**ADDENDUM TO INVITATION FOR BIDS**

**Mattole Valley Charter School**

**Diamond View HVAC Project**

Addendum #1

C. Location of units as sketched out by the Landlord (see attachment):

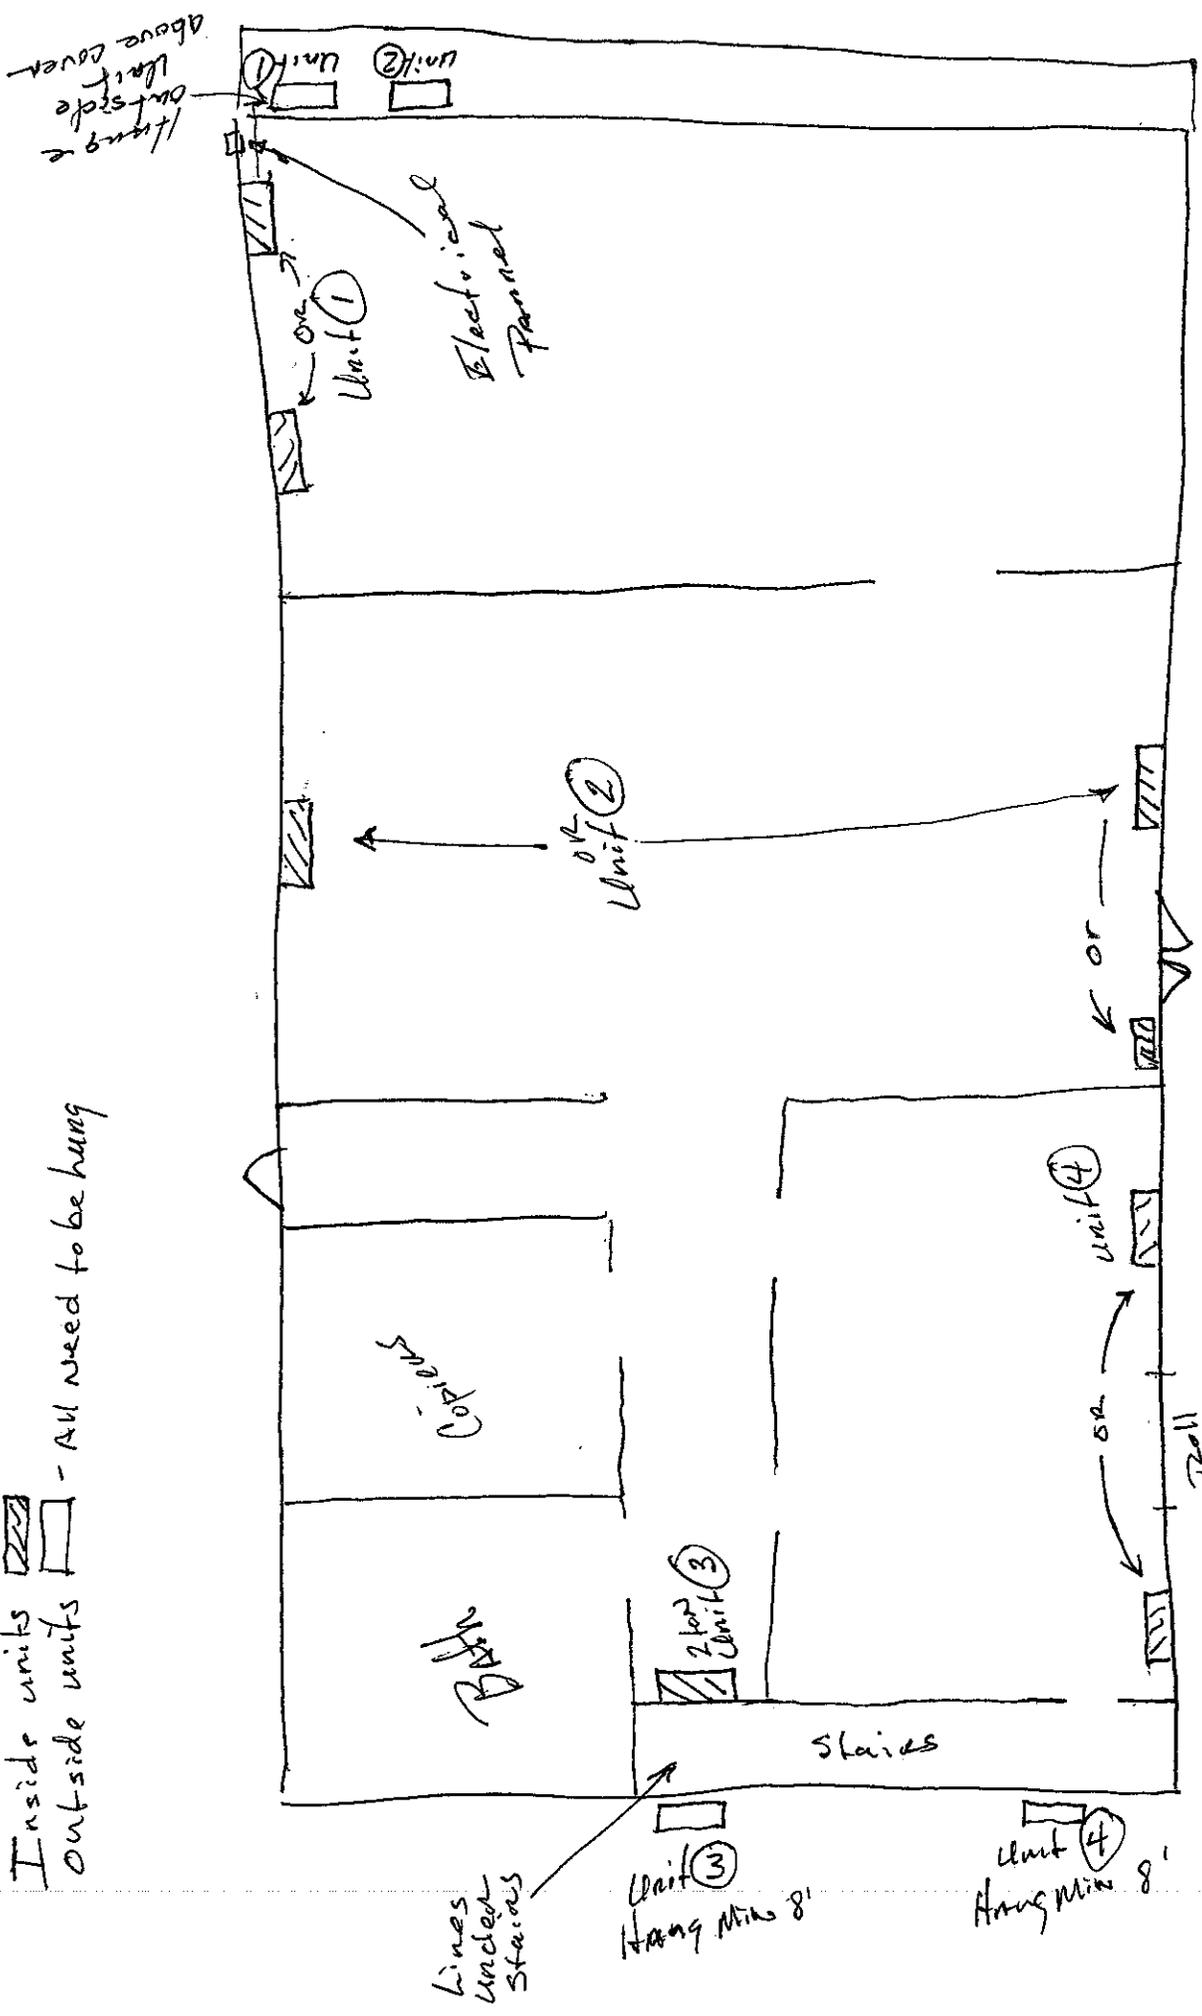
4 unit Heating/Ac 2 ton Mitsubishi

Inside units  Outside units  - All need to be hung
